INDIANA DEPARTMENT OF TRANSPORTATION

APPROVED MINUTES

February 16, 2012 Standards Committee Meeting
(The changes made to the Final Draft Minutes
are shown highlighted in yellow)

RE: Minutes from the February 16, 2012 Standards Committee Meeting

EXISTING 706-BRPP-03 RAILING, PS-1 (WITH MARKUPS)

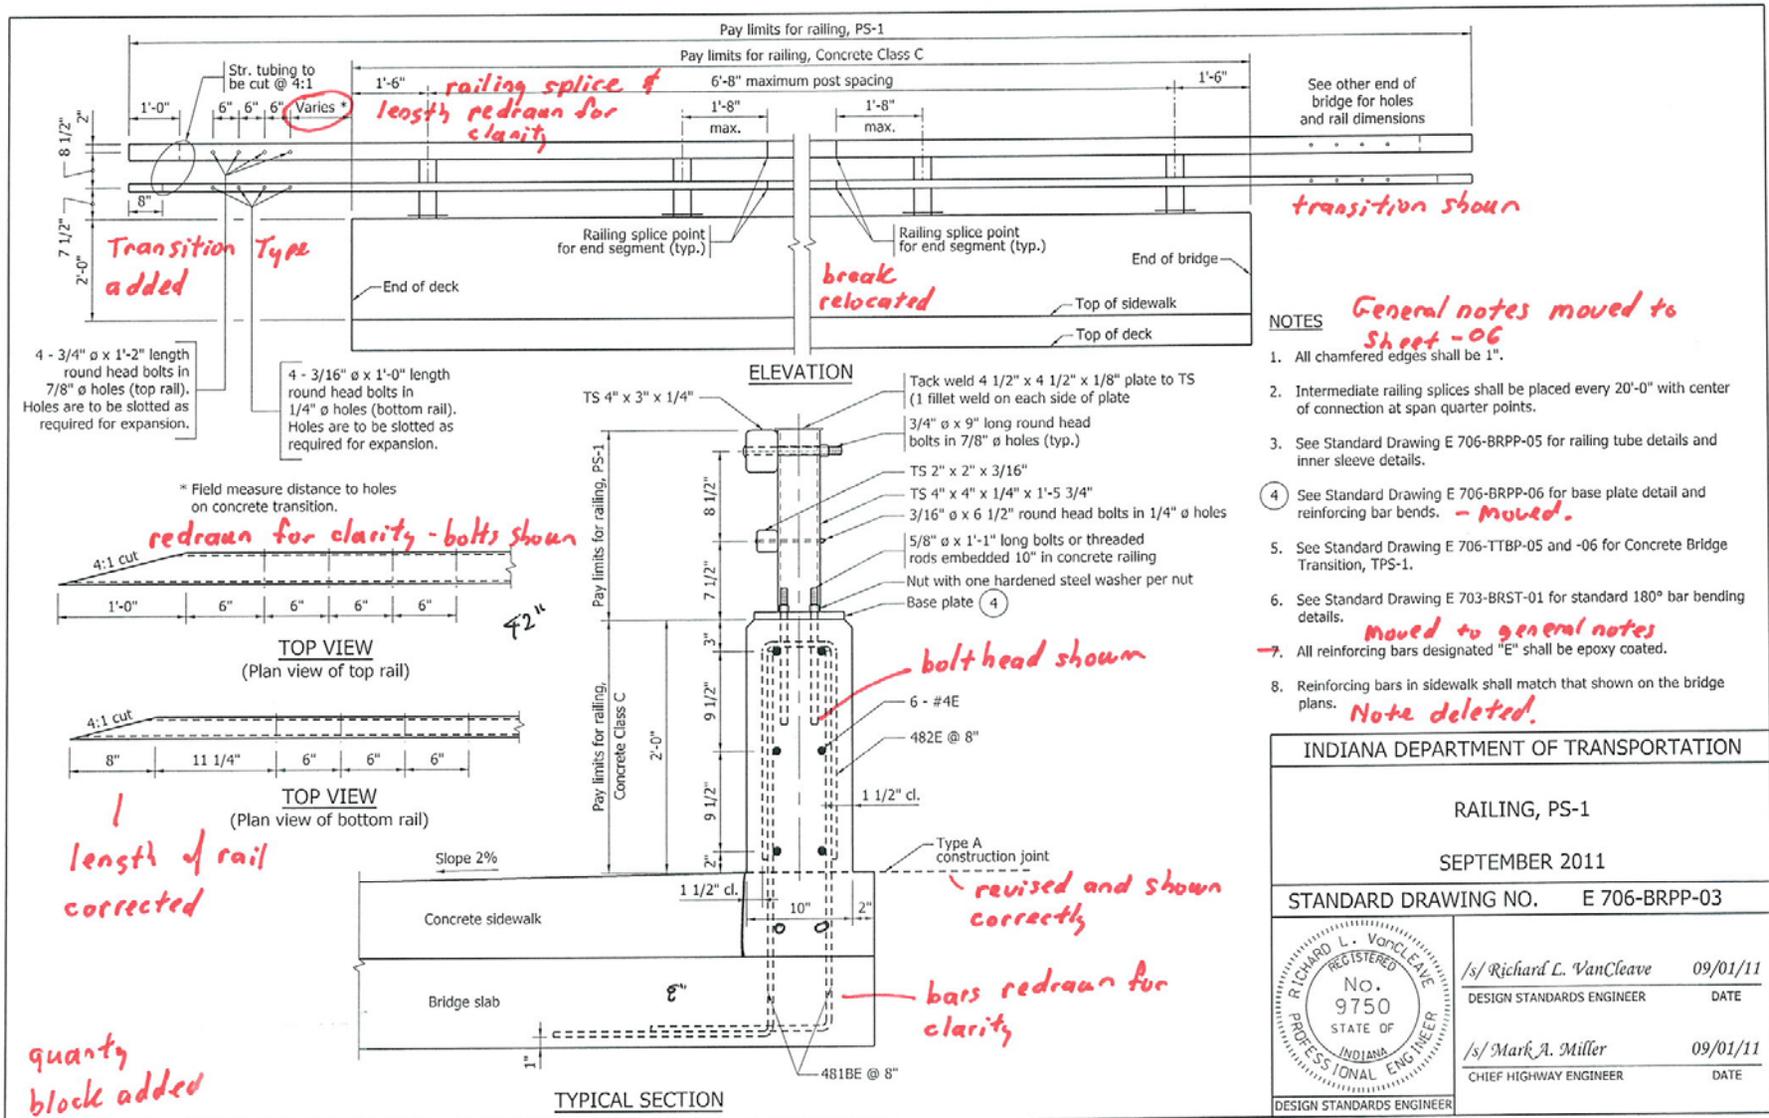
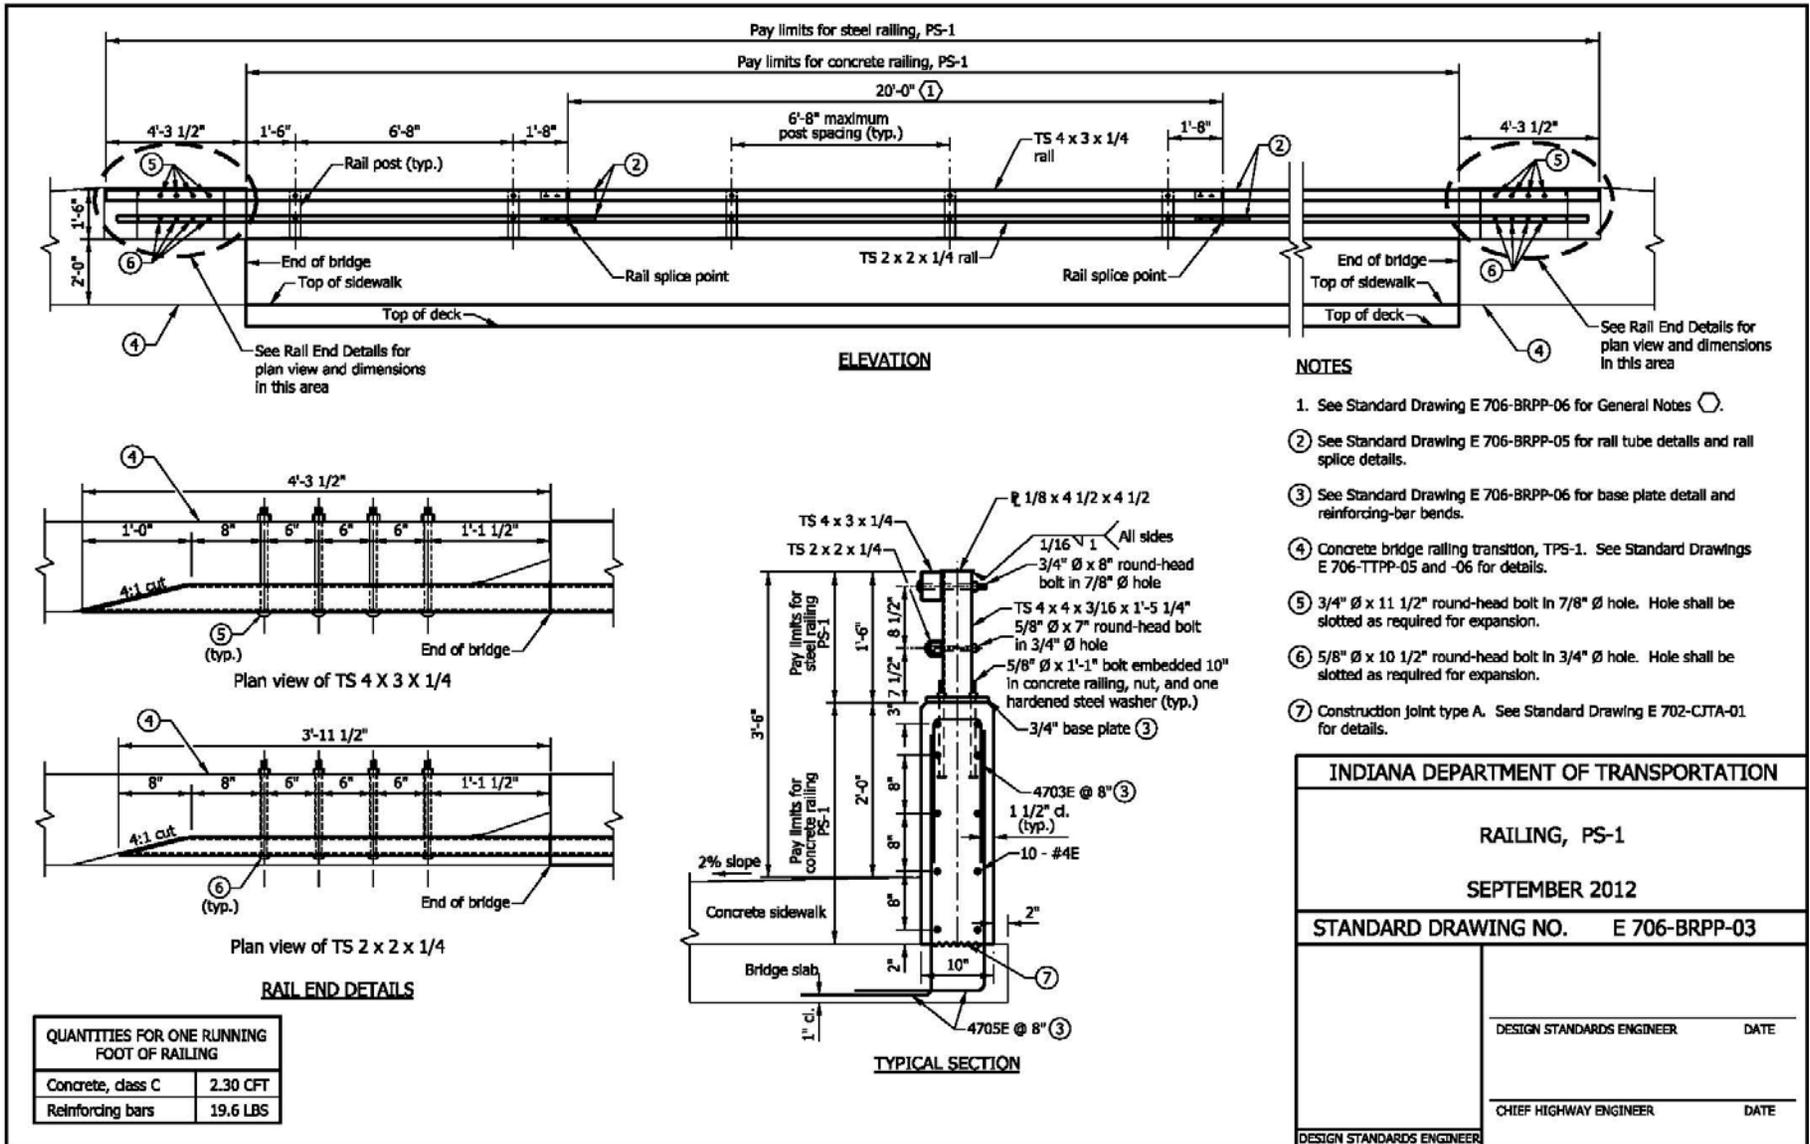
This is a TL-9 railing

REVISED 706-BRPP-03 RAILING, PS-1 (DRAFT)

INDIANA DEPARTMENT OF TRANSPORTATION	
CONCRETE BRIDGE RAILING TYPE TF-2	
SEPTEMBER 2005	
STANDARD DRAWING NO. E 706-BRTF-01	
	<i>/s/ Richard L. VanCleave</i> 9/9/05 DESIGN STANDARDS ENGINEER DATE
	<i>/s/ Richard H. Spitzer</i> 9/9/05 CHIEF HIGHWAY ENGINEER DATE

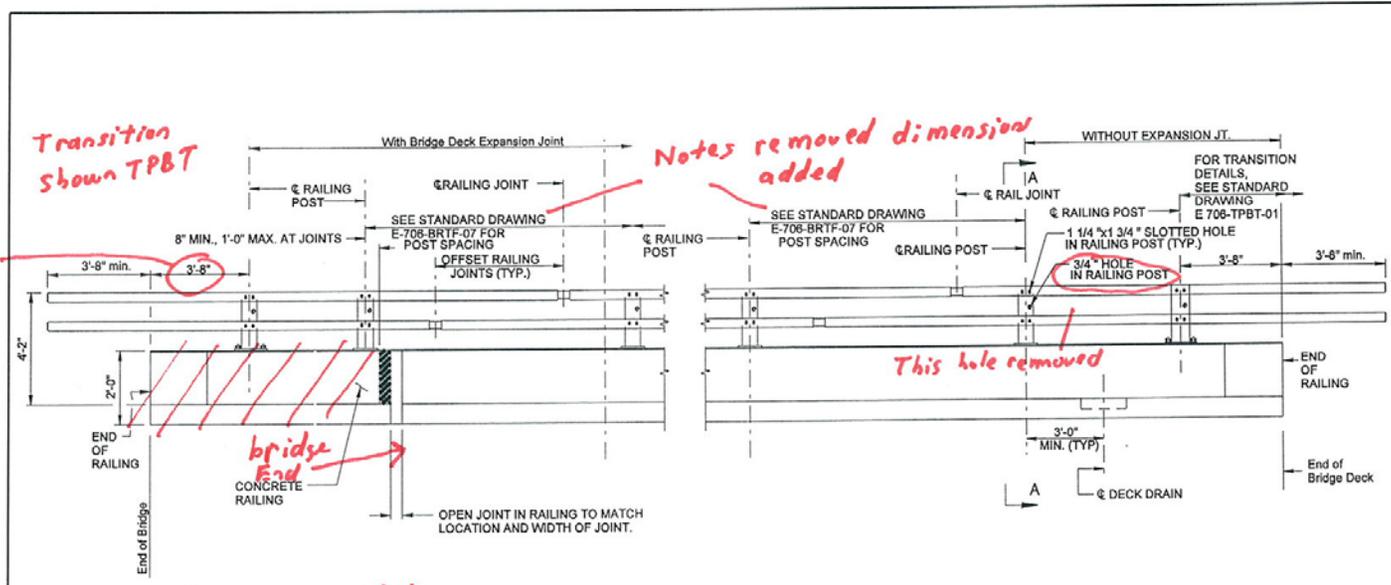
Transition shown TPBT

Notes removed dimension added

This hole removed

*Typical Section added
 rail end detail added*

NOTES: *Revised - added.*

1. See Standard Drawing E 706-BRTF-02 FOR SECTION A - A. *Section placed on sheet*
2. See Standard Drawing E 703-BRST-01 for bending details and reinforcing steel notes. *- Note move to sheet with bent bar*
3. Pay limits for concrete bridge railing Type TF-2 to end of railing. *limits shown*

quantity block added

EXISTING 706-BRTF-08 CONCRETE BRIDGE RAILING TYPE TF-2. RAILING SPLICE DETAIL (PROPOSED TO DELETE)

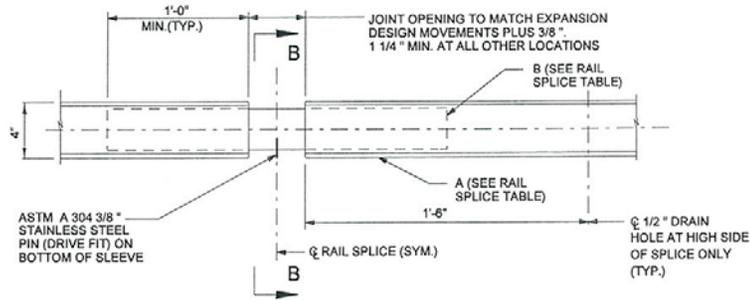
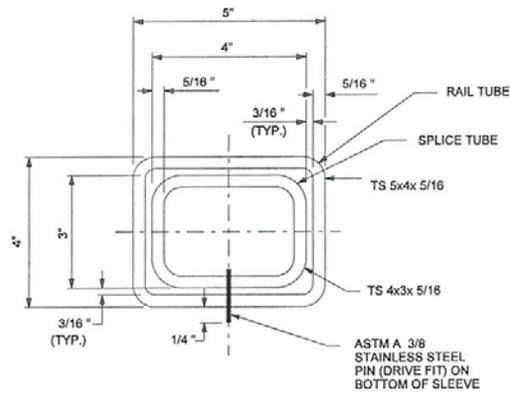
Shown on sheet 02

EXISTING 706-BRTF-09 CONCRETE BRIDGE RAILING TYPE TF-2 (PROPOSED TO DELETE)

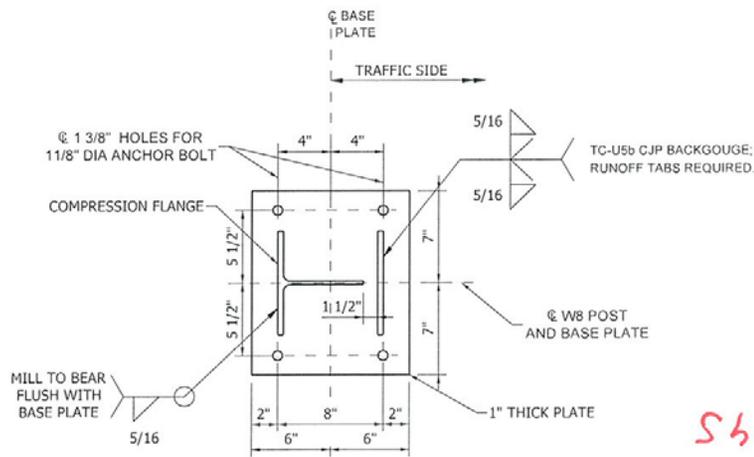
Shown on sheet 03

EXISTING 706-BRTM-01 RAILING, CF-1 (PROPOSED TO DELETE)

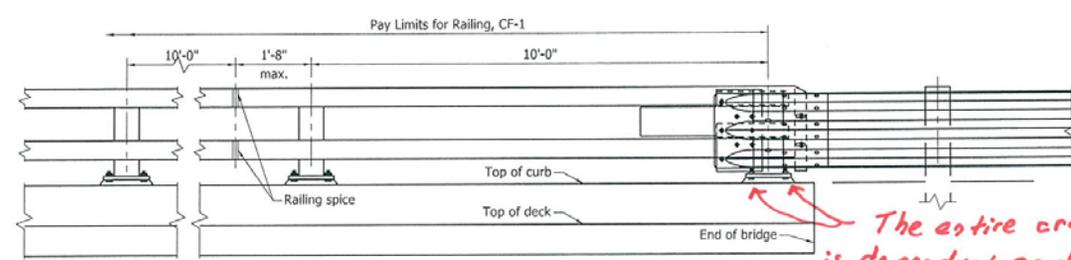
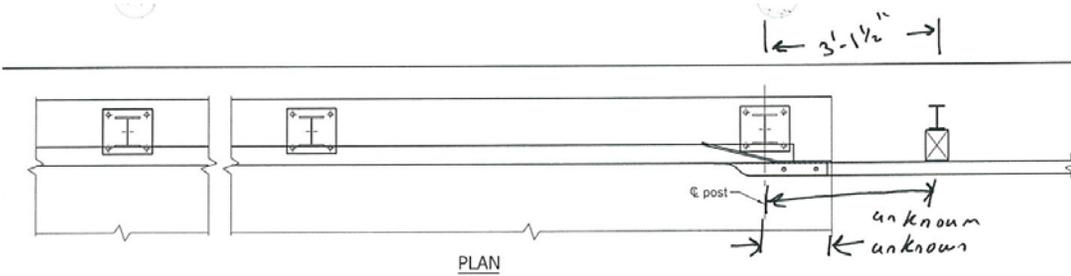
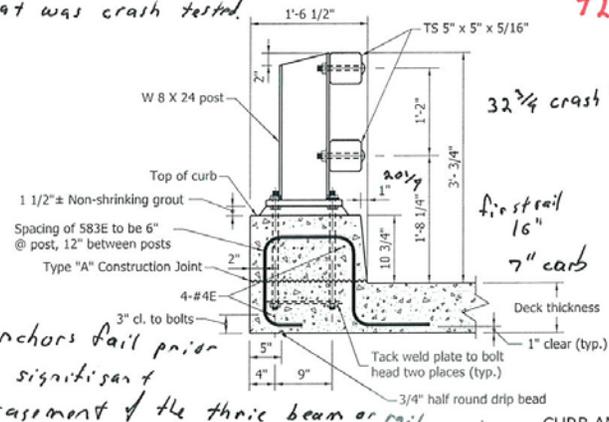
A 36 3/4" rail was not what was crash tested.

The entire crash force is dependant on two bolts on this post. This is a crash tested T1-2 bridge rail - It is proposed that this bridge rail not be a standard.

This bridge rail can be used - It is recommended that this bridge rail NOT be a standard. The bridge end seems very unlaerable.

EXISTING 706-BRTX-03 RAILING, TX (WINDOW DETAILS) (WITH MARKUPS)

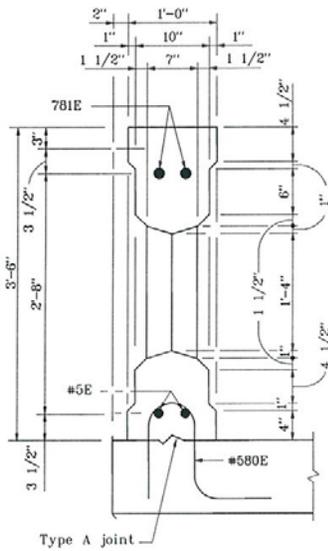
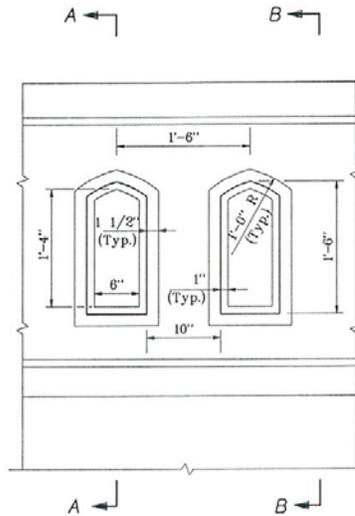
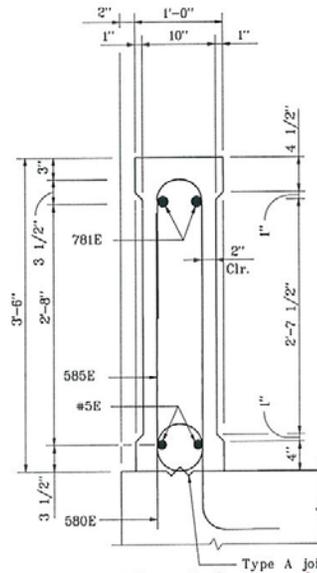
Shown on sheet 4

Section added.

SECTION B-B *Show joint as typical*

ben + bars shown on sheet 4

detail all steel correctly

EXISTING 706-TBRC-01 RETROFIT THRIE BEAM BRIDGE RAILING TR (WITH MARKUPS)

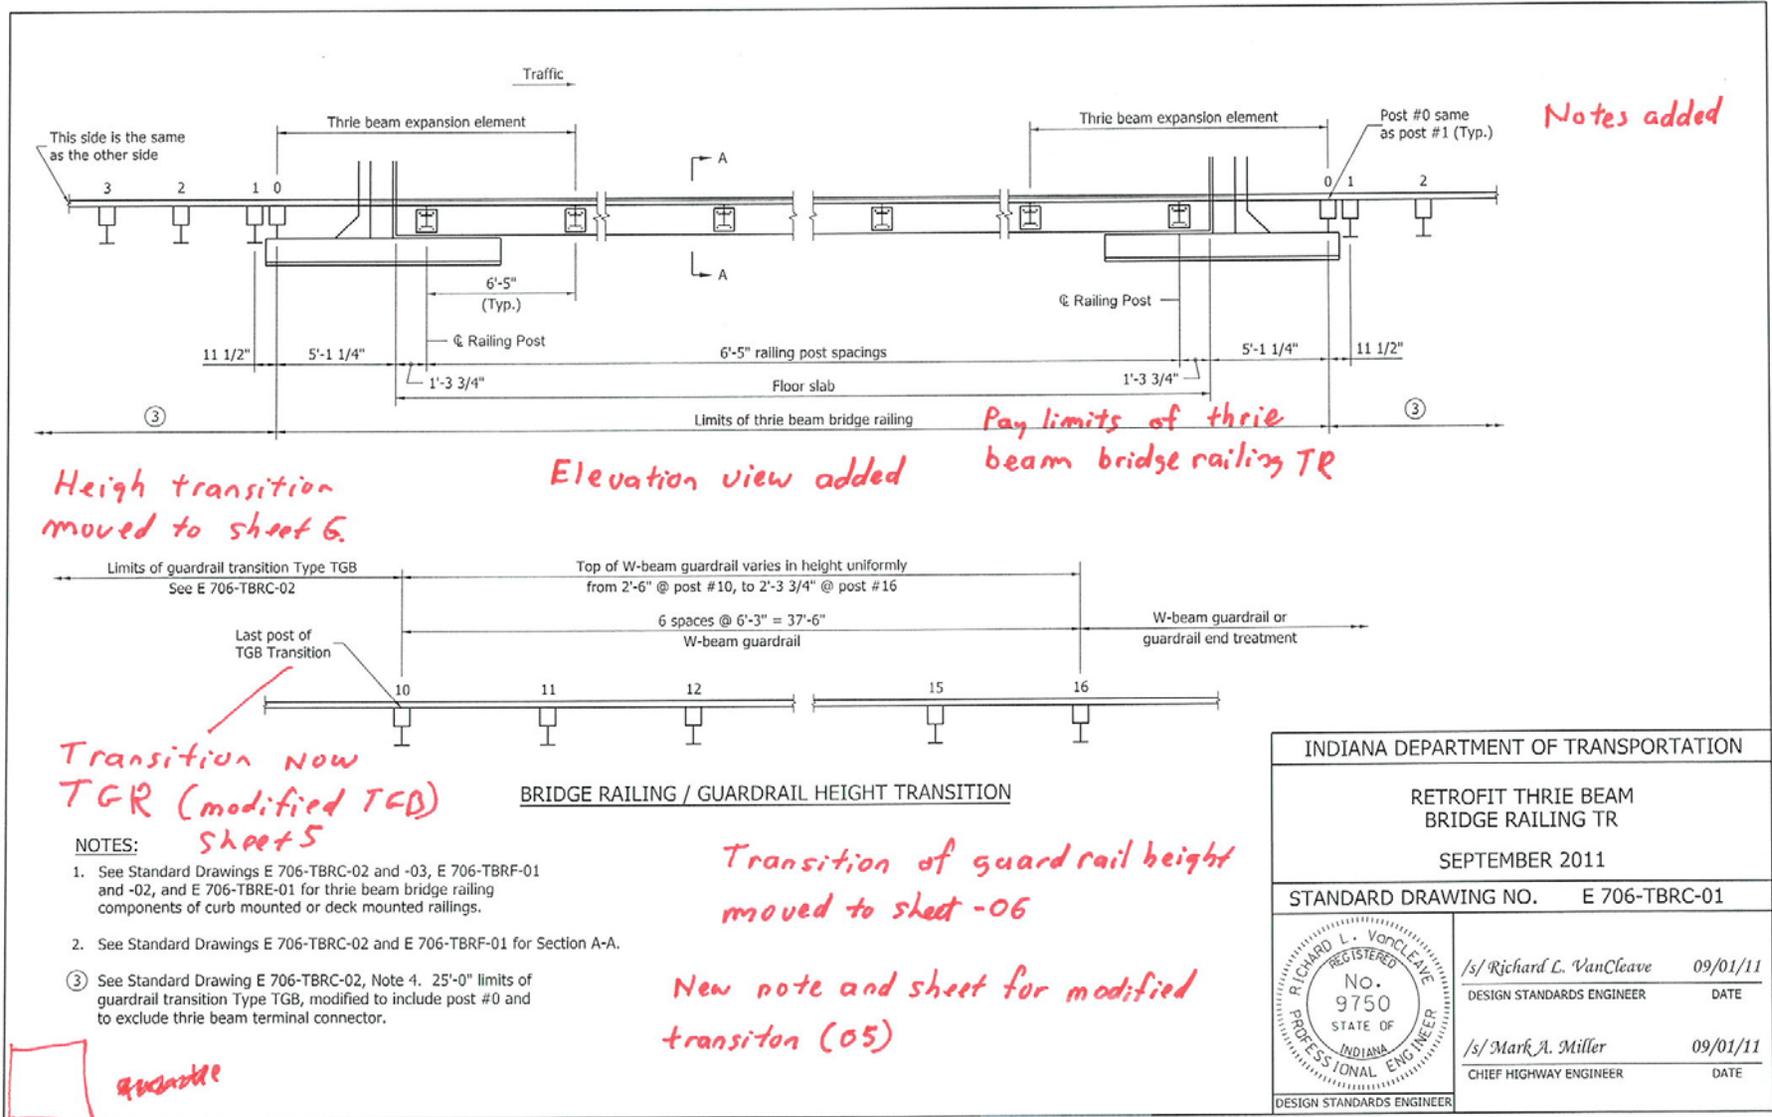
Heigh transition moved to sheet 6

Elevation view added

Transition now TGR (modified TGD) sheet 5

Transition of guard rail height moved to sheet -06

New note and sheet for modified transition (05)

EXISTING 706-TBRE-01 RETROFIT THRIE BEAM BRIDGE RAILING TR COMPONENTS (WITH MARKUPS)

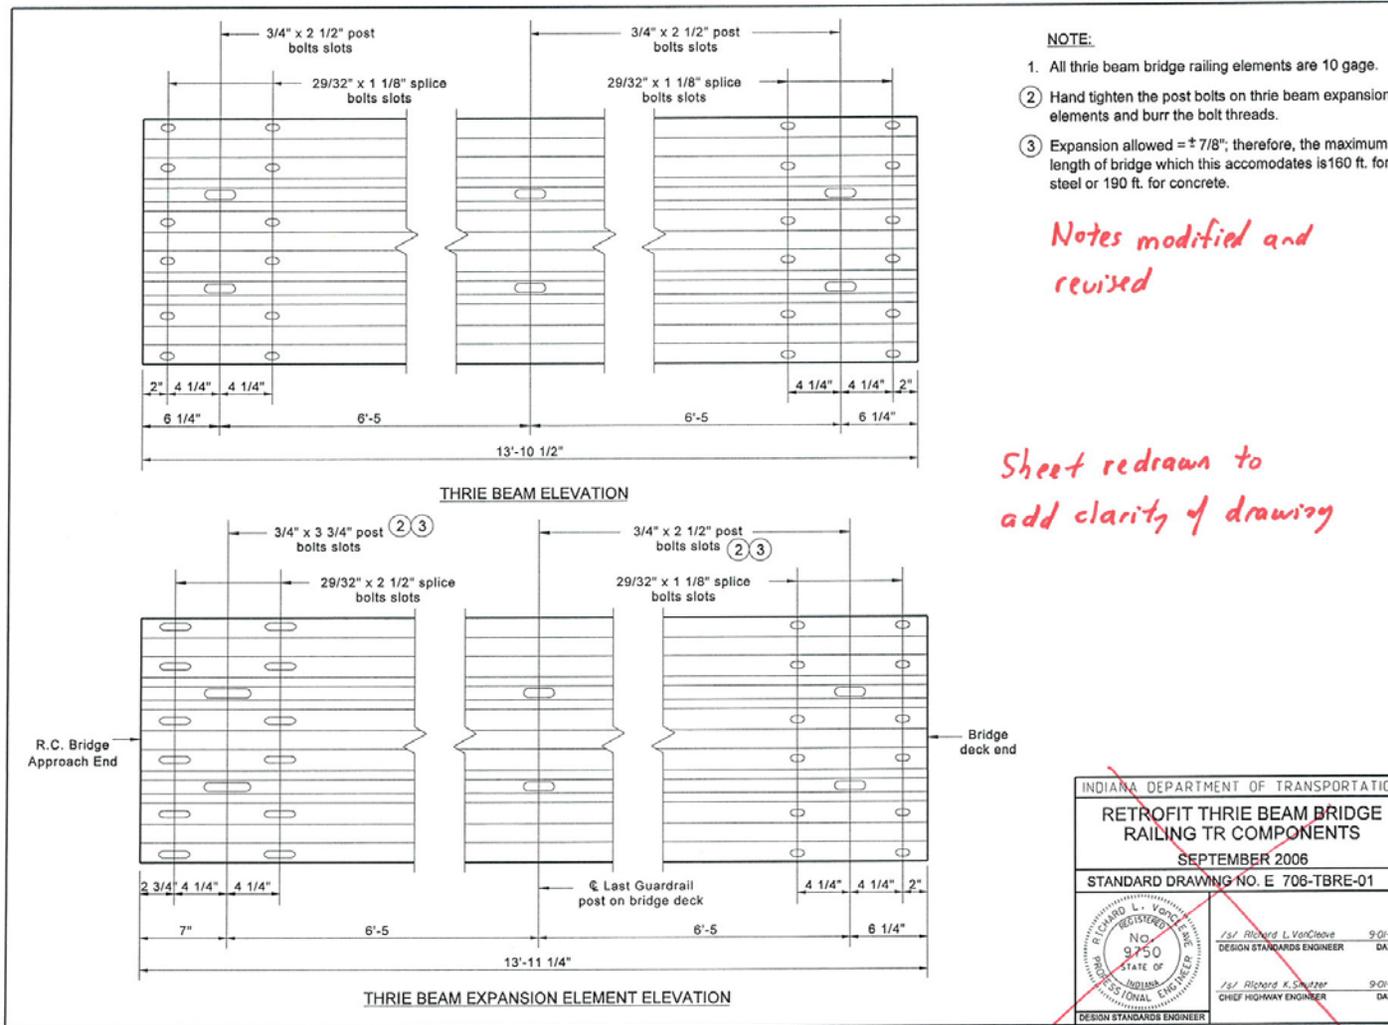
*706-TBRE-01
 Now 706-TBRE-07*
